**NCC 2022 Section J Vol. 1 J1V3 Assessment**  
**135 Badgerys Creek Road, Bradfield**  
**Creative Vision**

Issue	Project	Description	Author	Checked	Date
1.0	P22001	NCC Section J 2022 J1V3 Assessment	SN	LW	29 <sup>th</sup> August 2025

Aspire Sustainability Consulting has been engaged to assess the non-Class 2 components of the proposed mixed-use development at 135 Badgerys Creek Road, Bradfield, NSW 2556, against Section J Verification Method J1V3 of the 2022 National Construction Code (NCC) Volume 1. This advice covers Section J Parts J4-J5. J Parts J6-J9 must be achieved in design by relevant services disciplines for the whole development.

PROJECT NUMBER  
20799  
DRAWING NUMBER  
DA-10B1

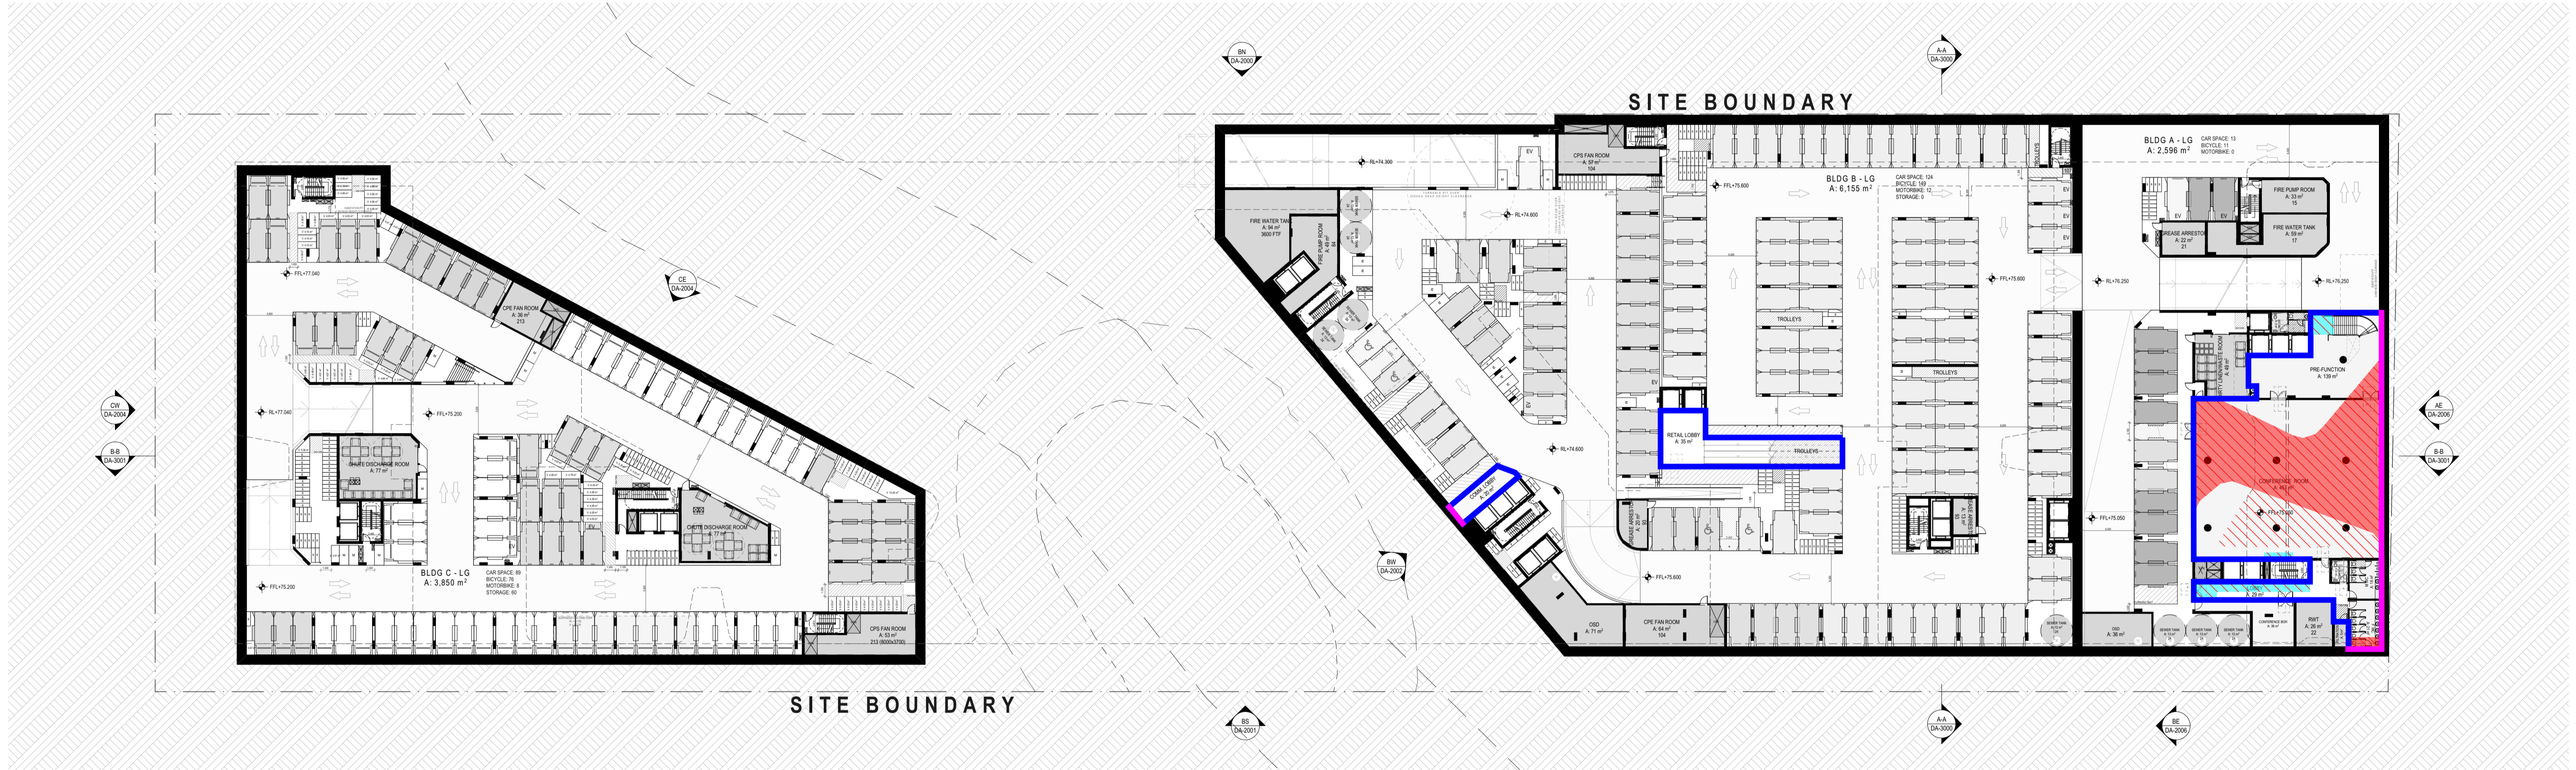
Floor:

External Wall:

Internal Wall:

Please refer to Section 5.1.1, 5.1.3 & 5.1.5 for detailed requirements regarding the required R-values for building fabric within the Thermal Envelope.

DRAWING NUMBER  
DA-1000

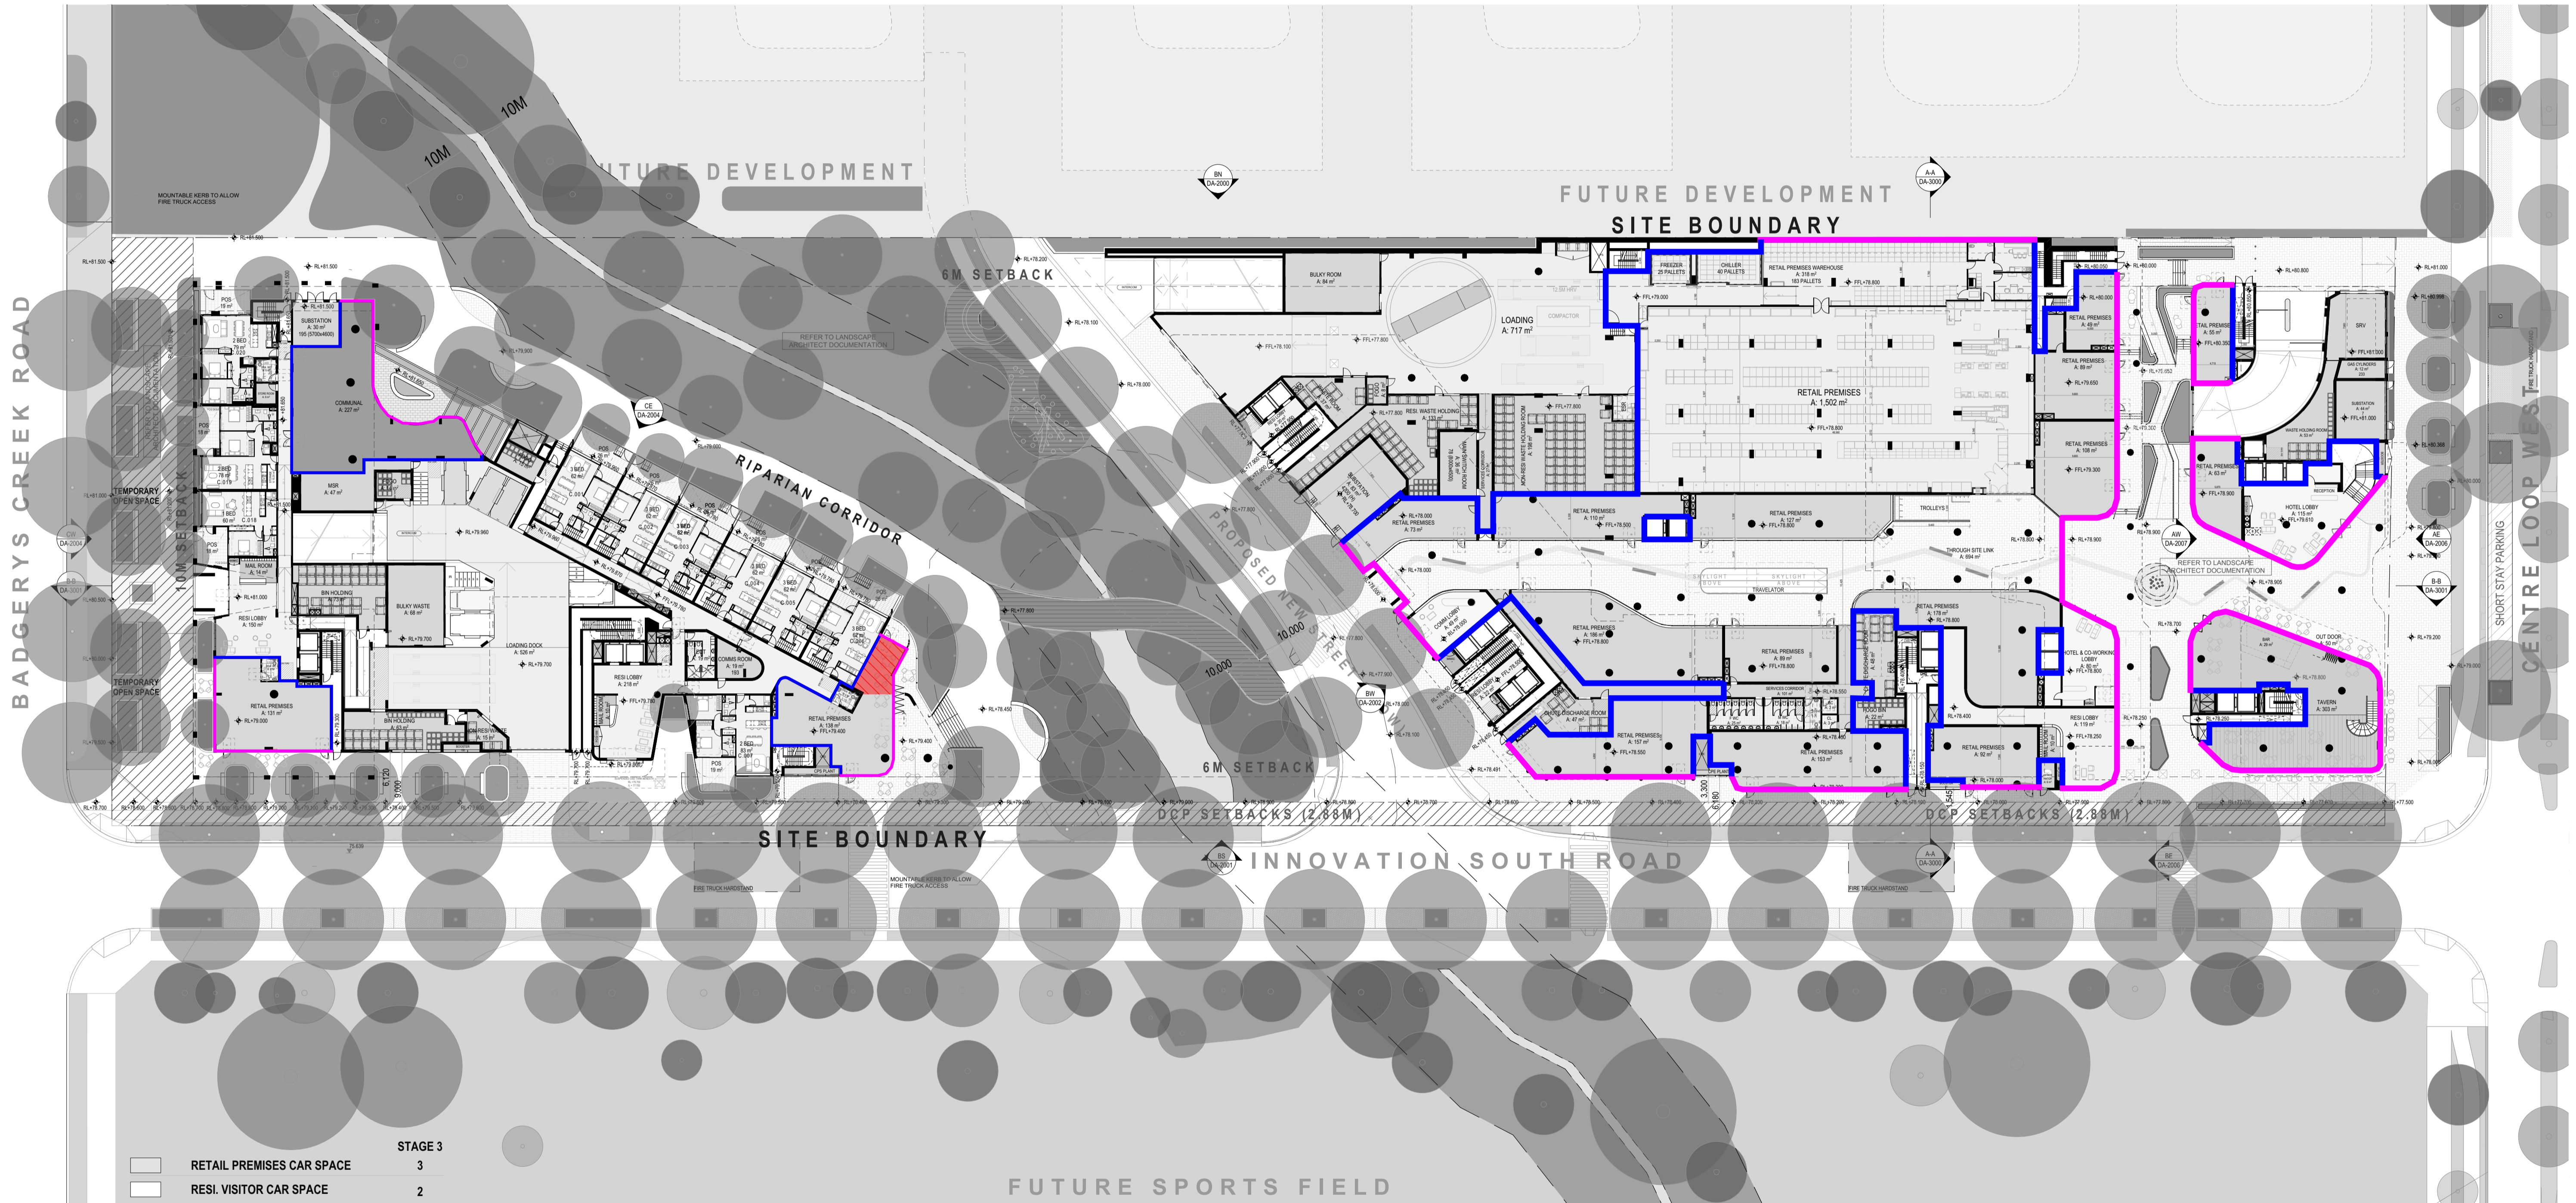
Roof:

Ceiling:

Floor:

External Wall:

Internal Wall:

Please refer to Section 5.1.1, 5.1.3 & 5.1.5 for detailed requirements regarding the required R-values for building fabric within the Thermal Envelope.

PROJECT NUMBER  
20799  
DRAWING NUMBER  
DA-10M1

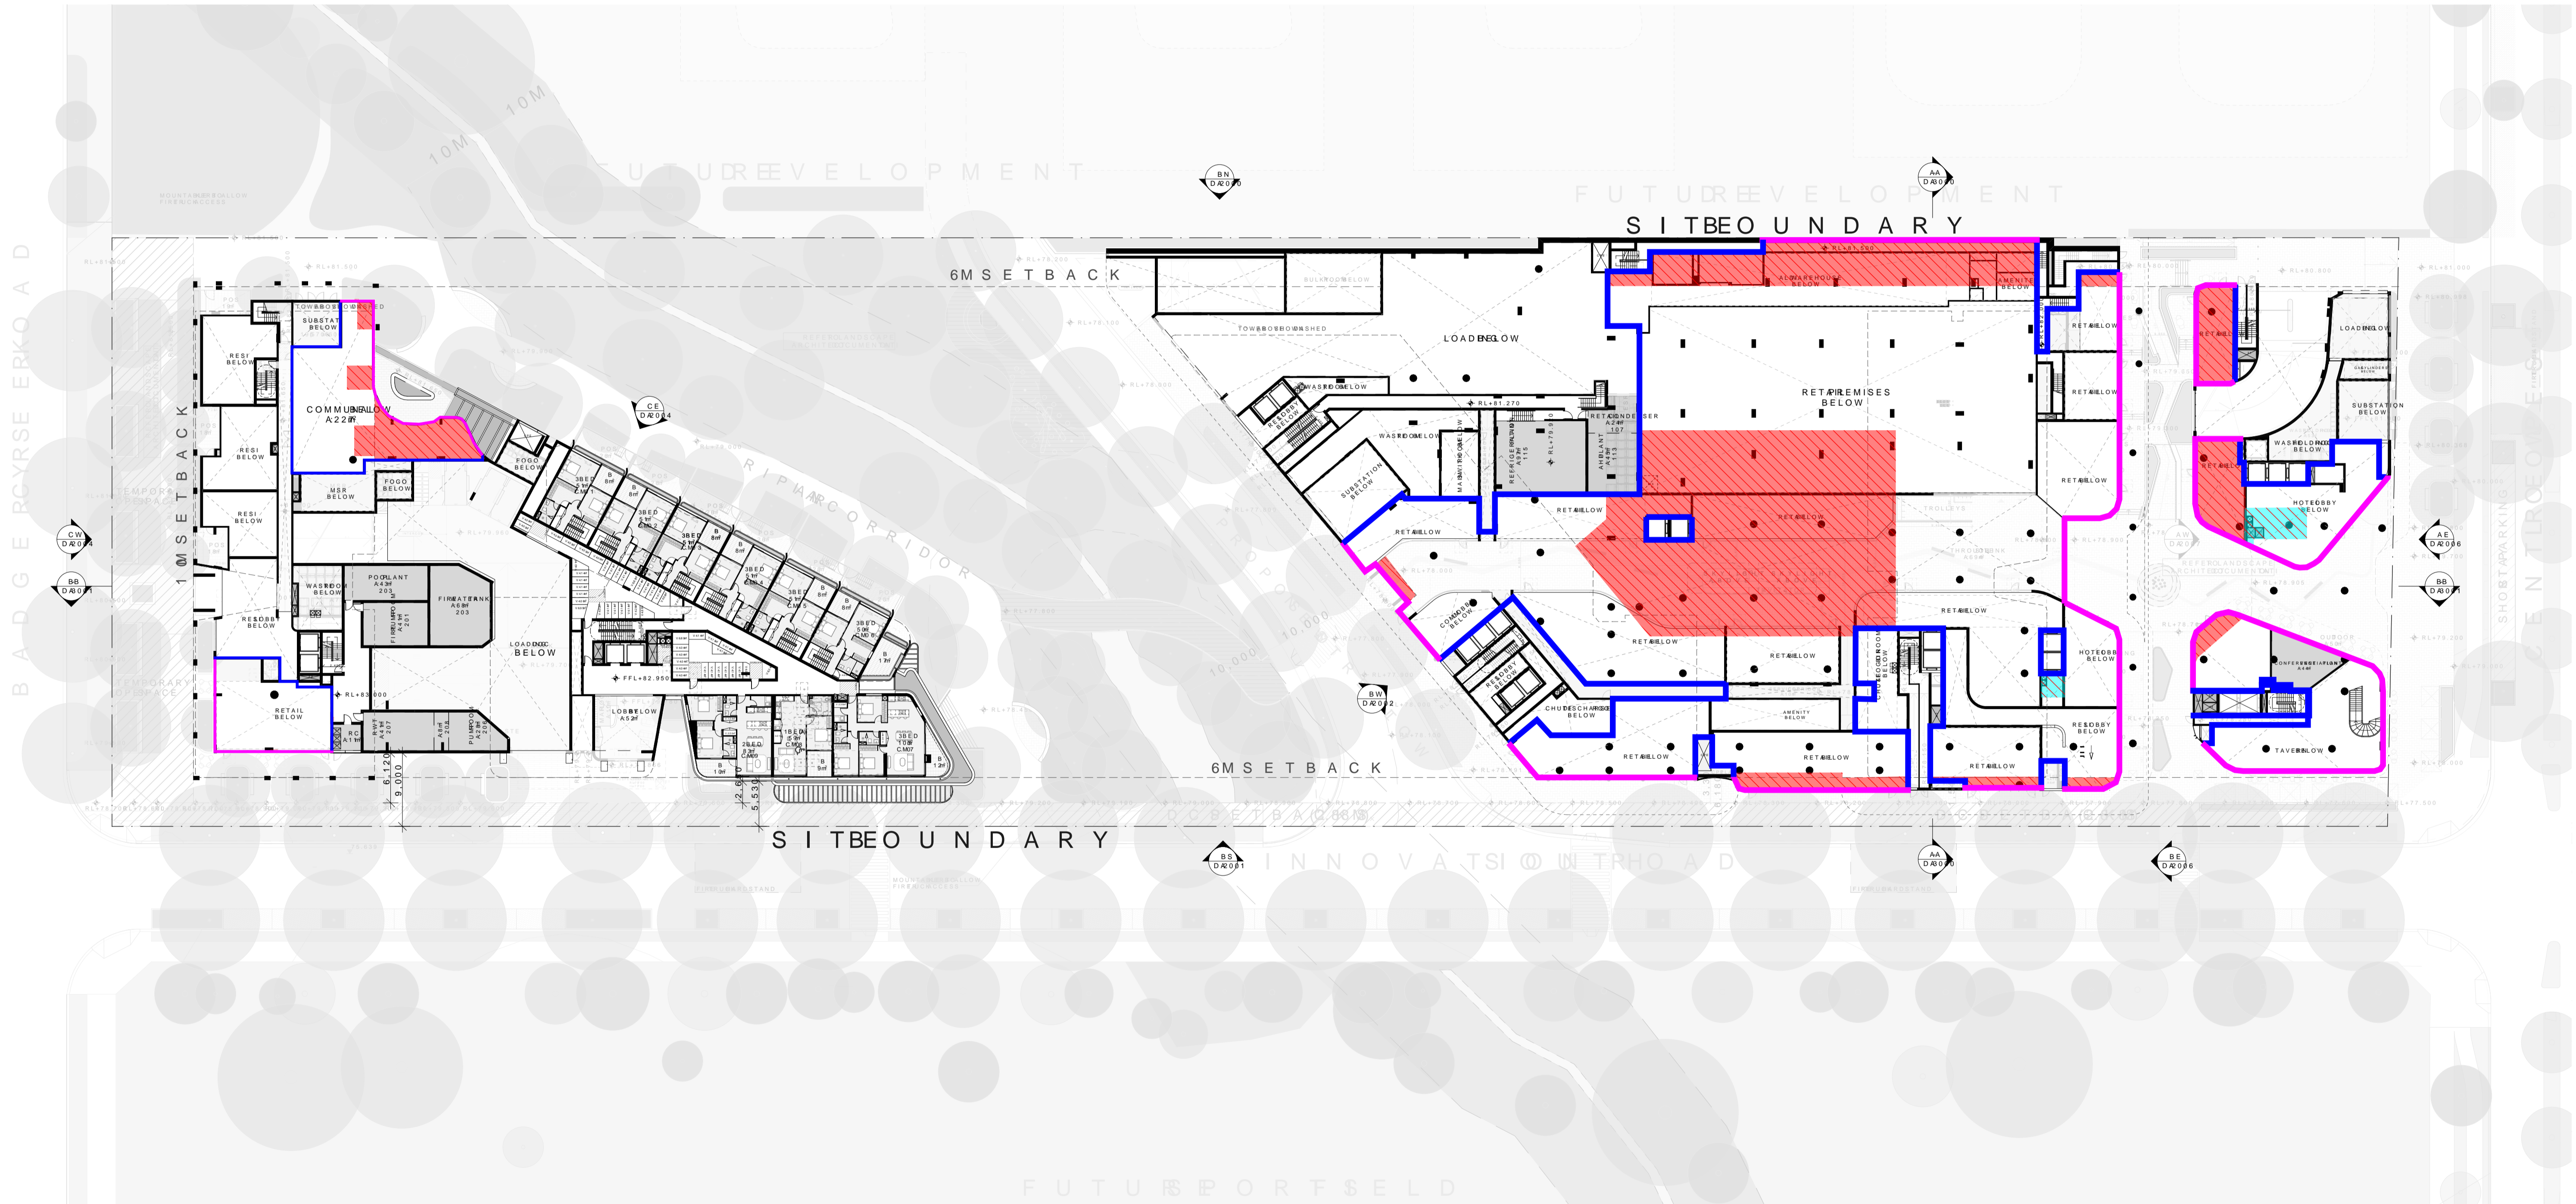
Roof:

Ceiling:

Floor:

External Wall:

Internal Wall:

Please refer to Section 5.1.1, 5.1.3 & 5.1.5 for detailed requirements regarding the required R-values for building fabric within the Thermal Envelope.

PROJECT NUMBER  
20799  
DRAWING NUMBER  
DA-1001

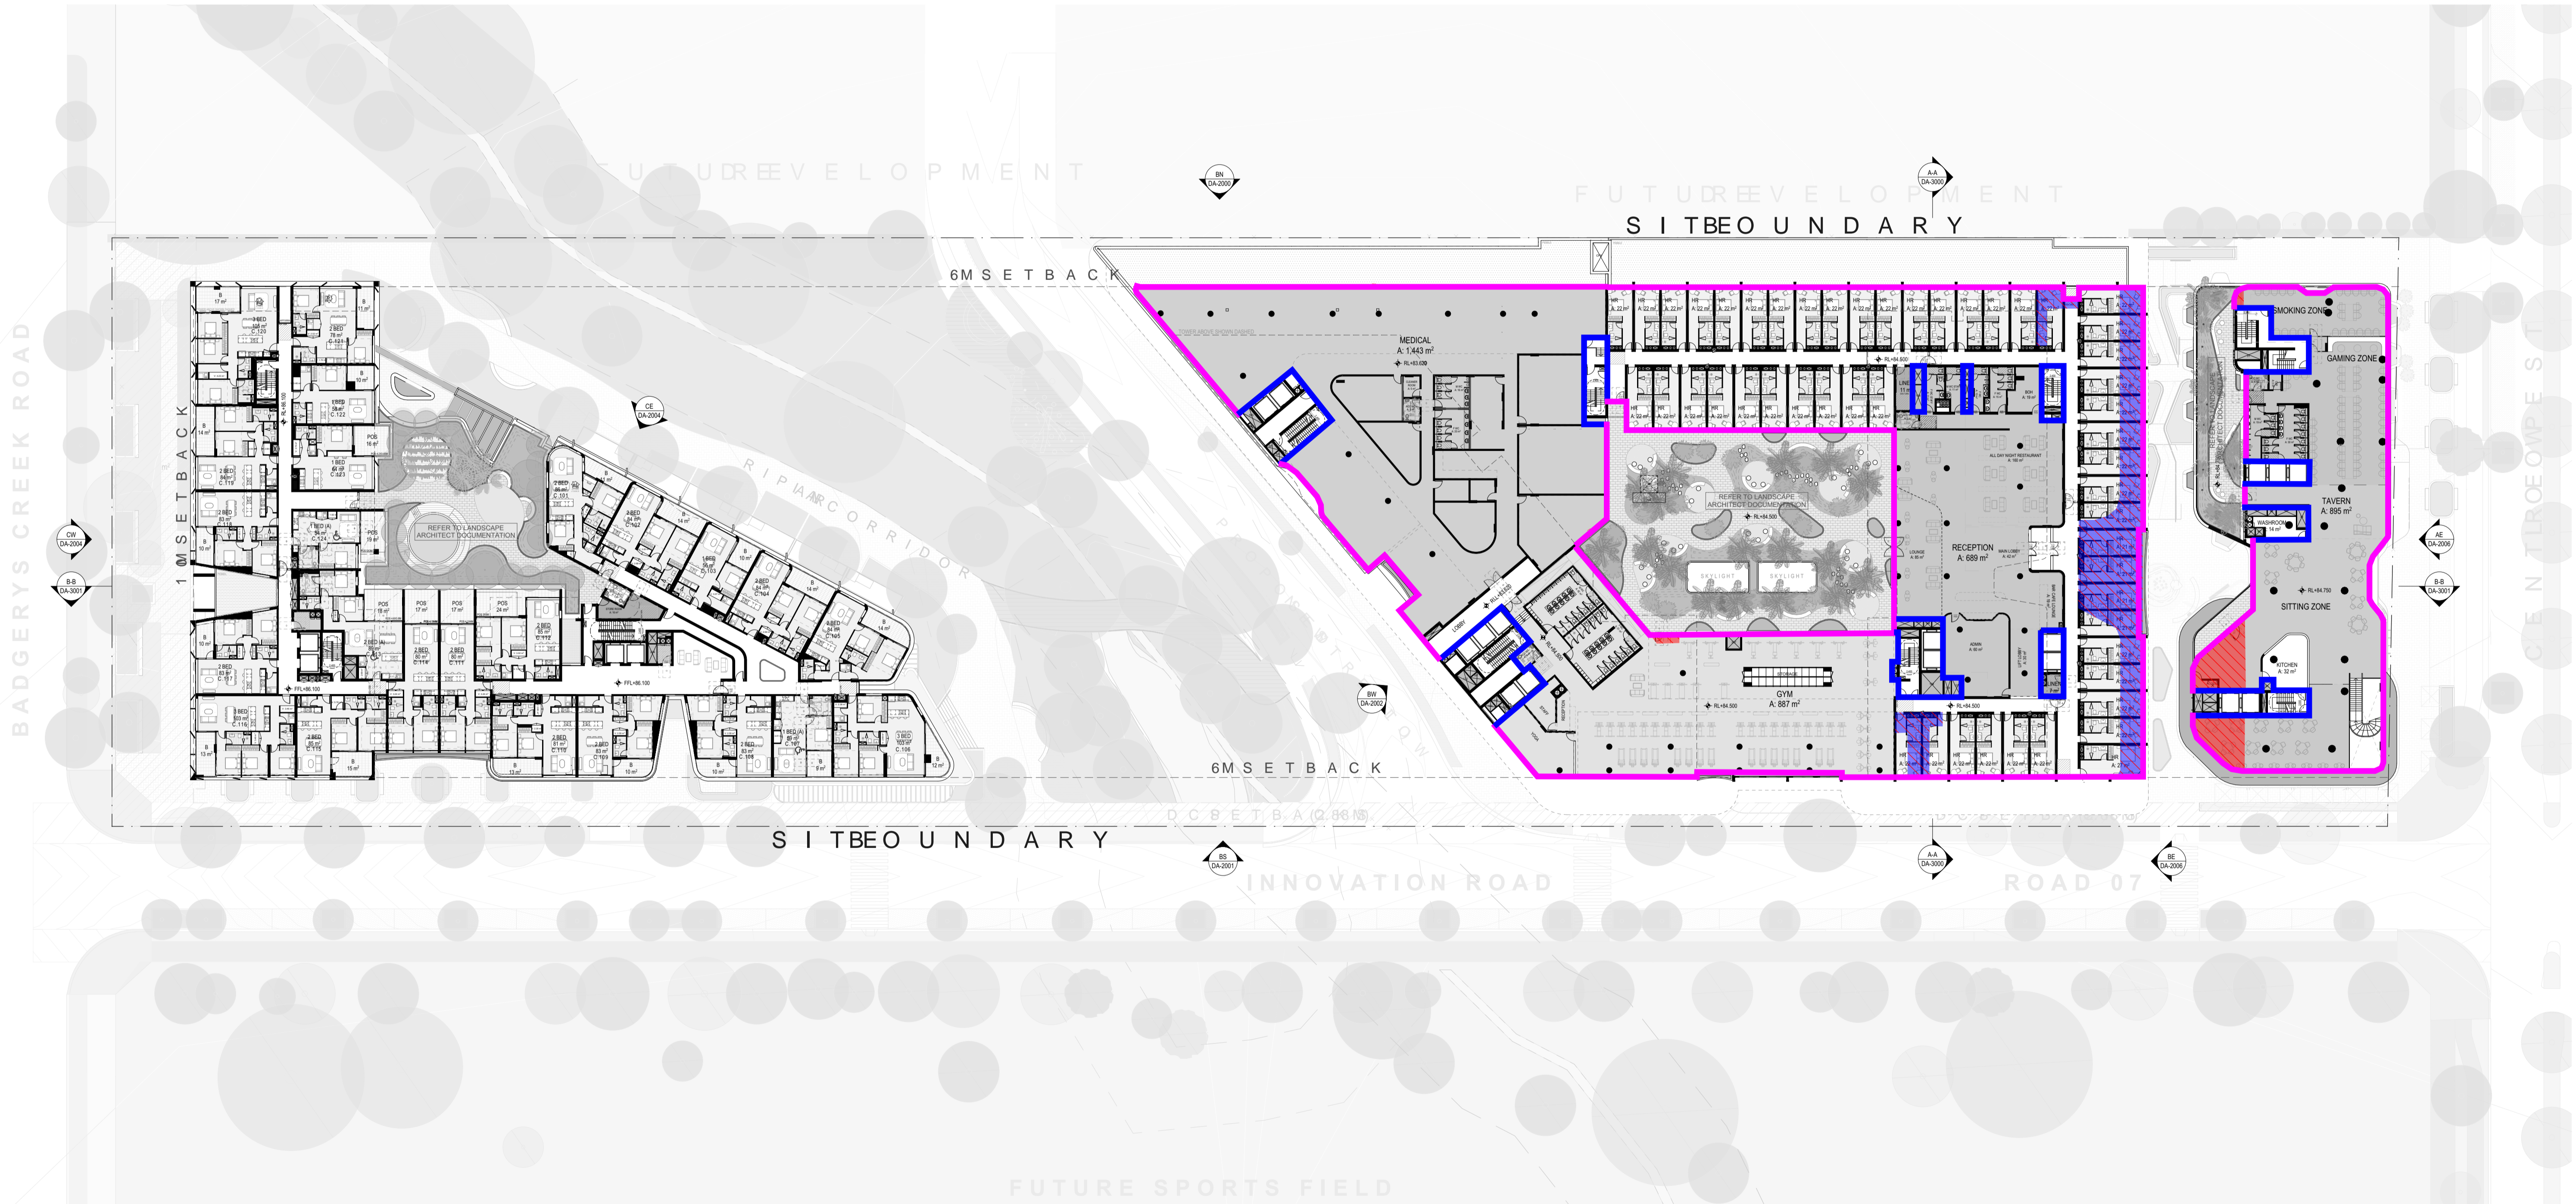
Roof:

Ceiling:

Floor:

External Wall:

Internal Wall:

Please refer to Section 5.1.1, 5.1.3 & 5.1.5 for detailed requirements regarding the required R-values for building fabric within the Thermal Envelope.
